2001 3.2TL - Glove Box Removal/Installation

Applies To: 1999-03 3.2 TL – ALL
2001-03 3.2 CL – ALL

Blower Motor Does Not Work

(Supersedes 06-006, dated February 14, 2006 to update the information with the black bars)

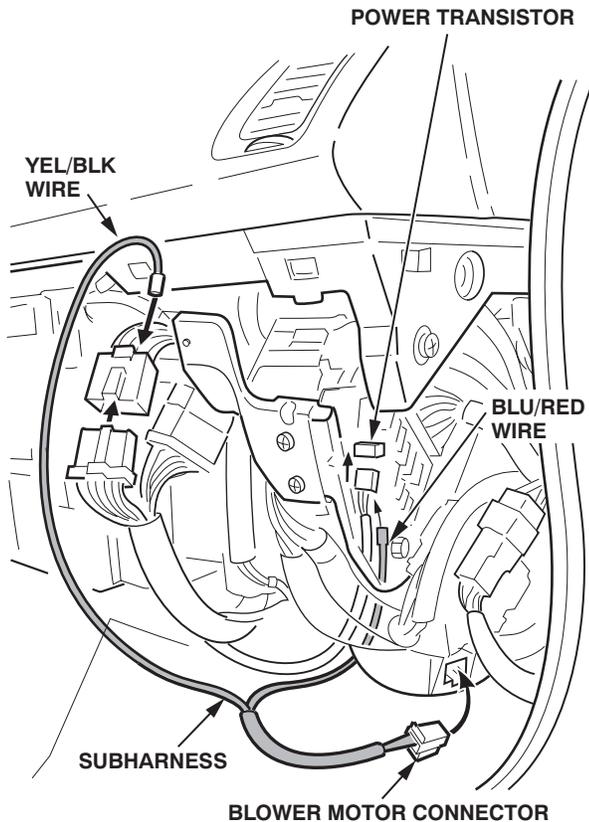
2. Disconnect the brown 7P connector (C202) from the main harness. Remove the YEL/BLK wire terminal from cavity 3 of connector C202. Cut off the terminal, and tape the remaining end of the wire to the harness.

3. Disconnect the 2P blower motor connector, cut off the connector, and tape the remaining ends of the wires to the pigtail. Then tape the pigtail to the main harness.
4. Disconnect the white 5P connector from the power transistor. Remove the BLU/RED wire terminal from cavity 4 of the power transistor connector. Cut off the terminal, and tape the remaining end of the wire to the harness.
5. Take the subharness, and insert the YEL/BLK wire terminal into cavity 3 of connector C202 and insert the BLU/RED wire terminal into cavity 4 of the power transistor connector. Tape both wires to the existing harness. Route the harness so there is no tension on the blower motor connector.

6. Reconnect connector C202 and the power transistor connector, then connect the 2P connector on the new subharness to the blower motor.
7. Verify the blower motor operates properly at all speeds.
8. Reinstall the glove box and cover.
